FED. ROAD DIST. NO.	STATE	PROJ. NO.	FISCAL YEAR	SHEET NO.	TOTAL SHEETS
HAWAII	HAW.	HWY-M-01-15M	2016	ADD . 11S-1	41

DEPARTMENT OF TRANSPORTATION GUARDRAIL DETAILS \≠ NOTES HANA HIGHWAY RESURFACING Haleakala Highway to Paia and HALEAKALA HIGHWAY RESURFACING Hana Highway to North Firebreak Rd.

Project No. HWY-M-01-15M Scale: As Shown Date: April, 2016

SHEET No. 5 OF 5 SHEETS ADD. 11S-5

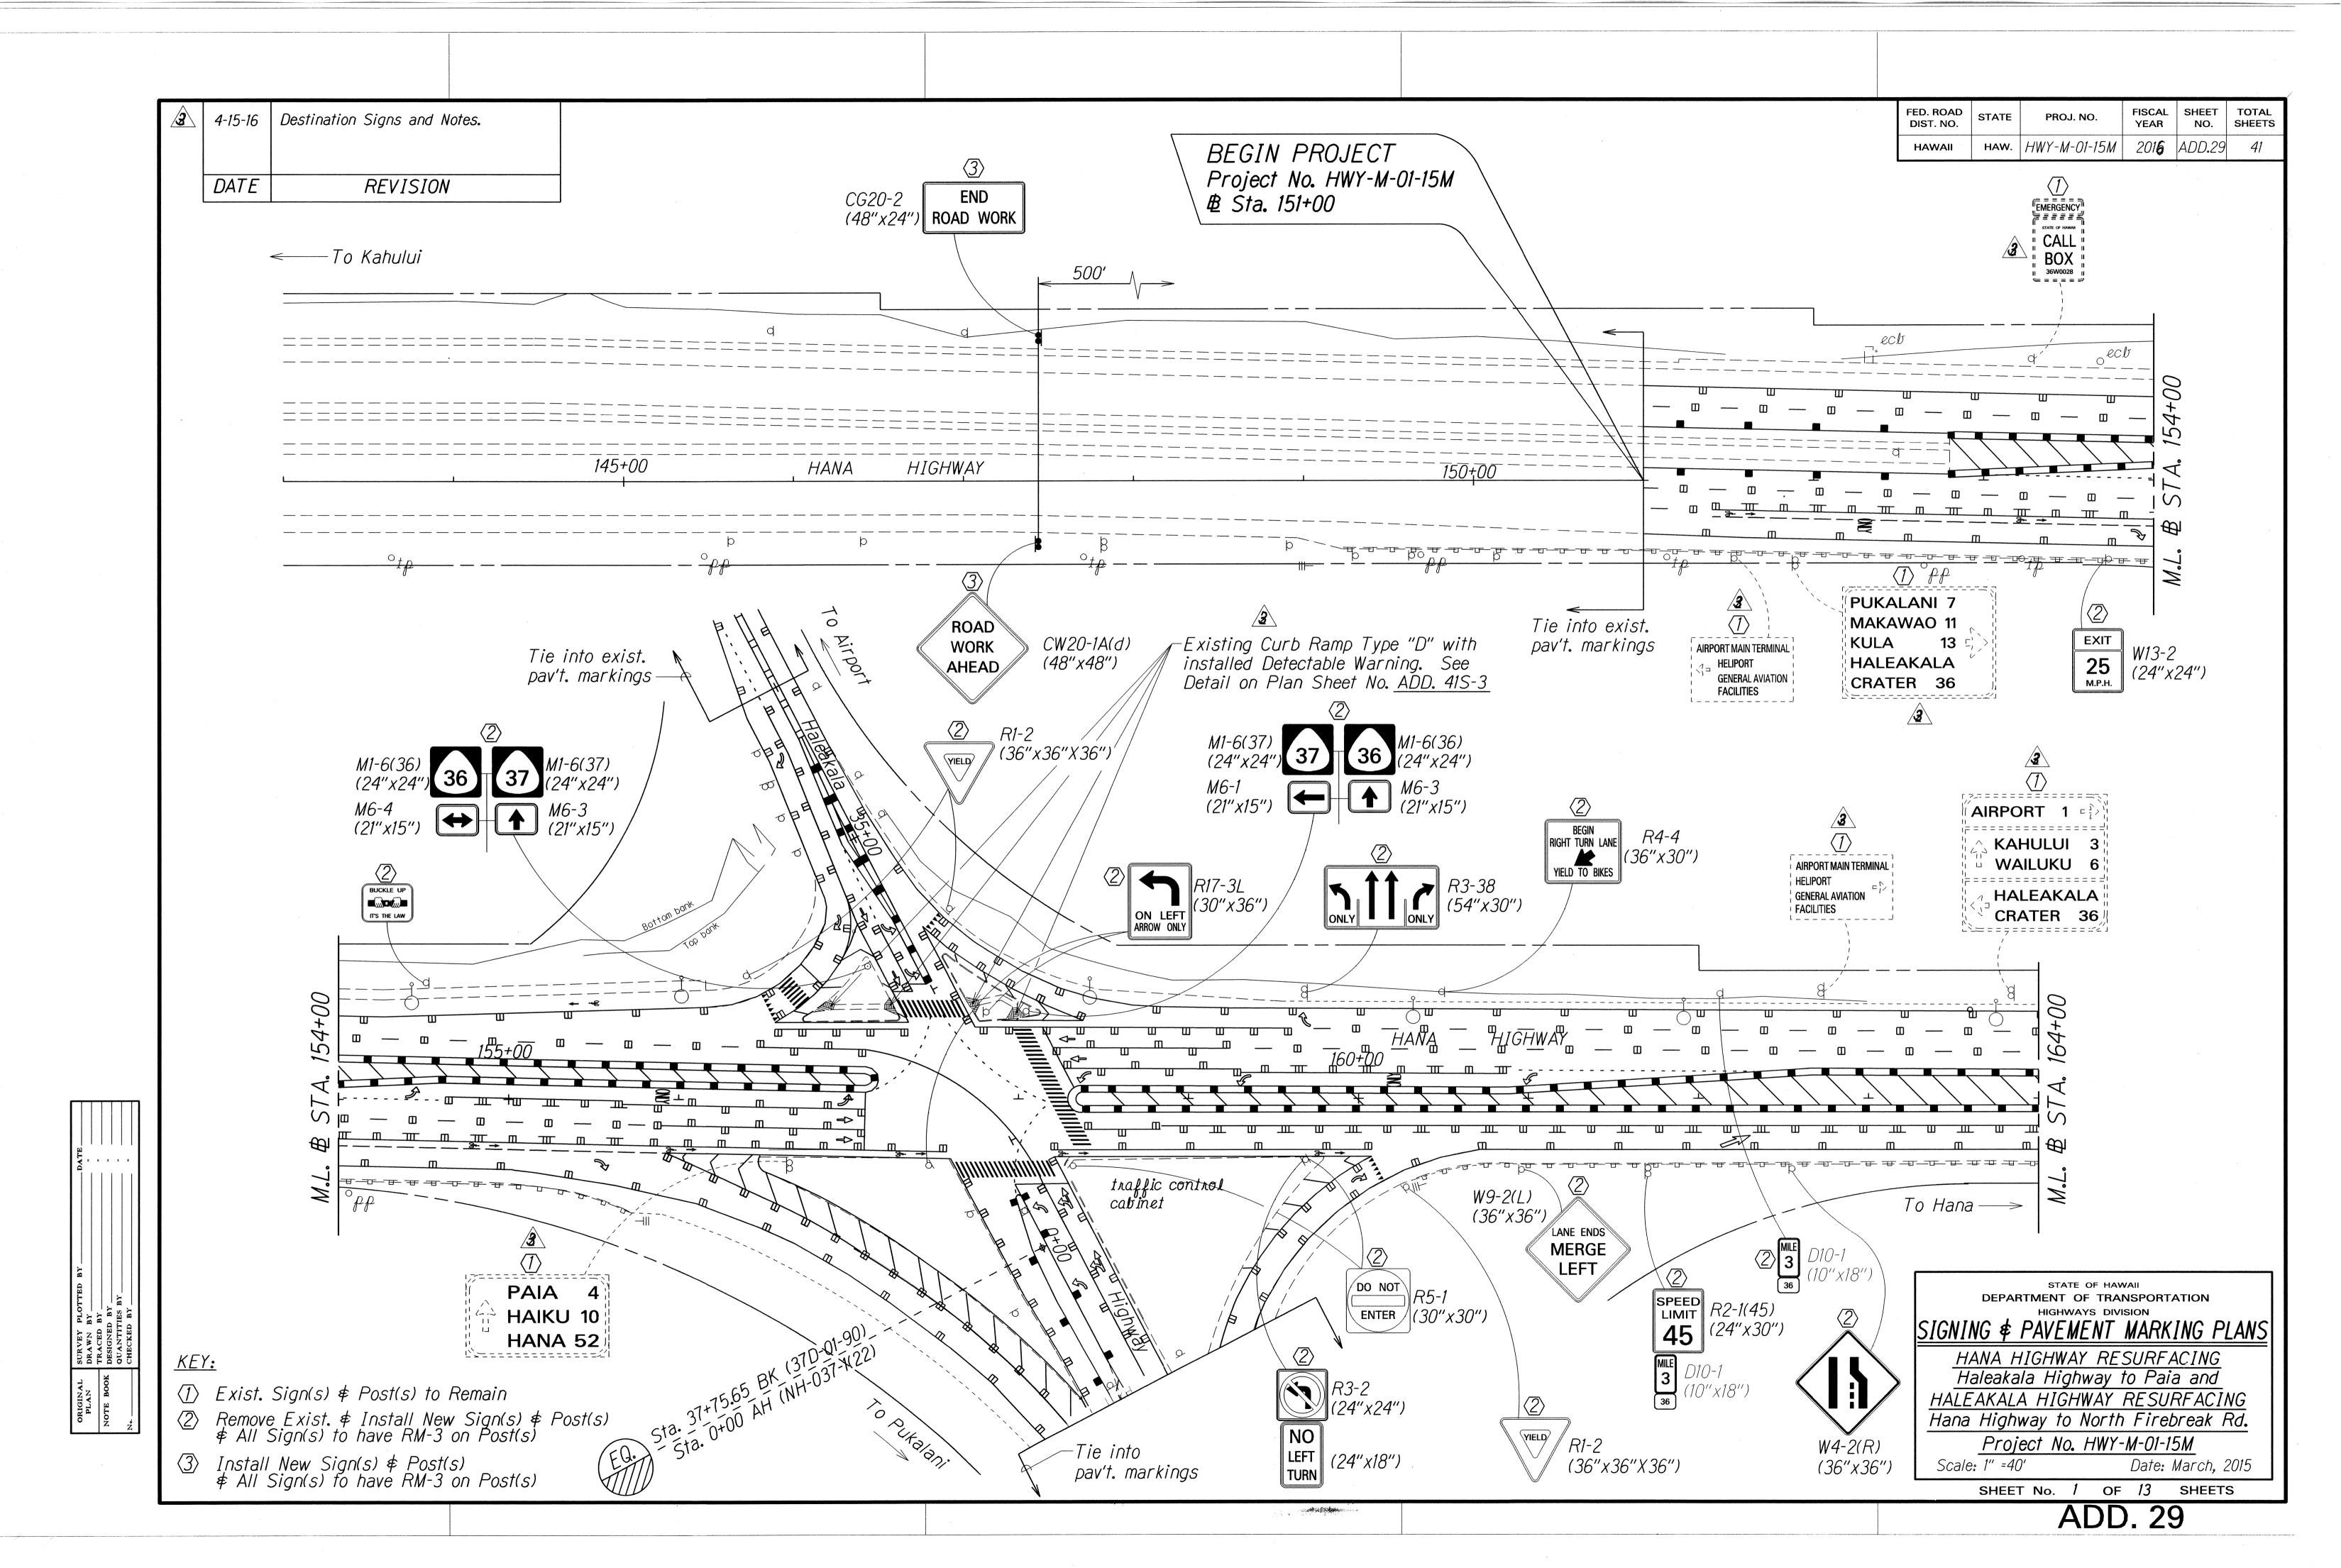
Additional Details of Type G End Terminal. 4-12-16 DATE REVISION
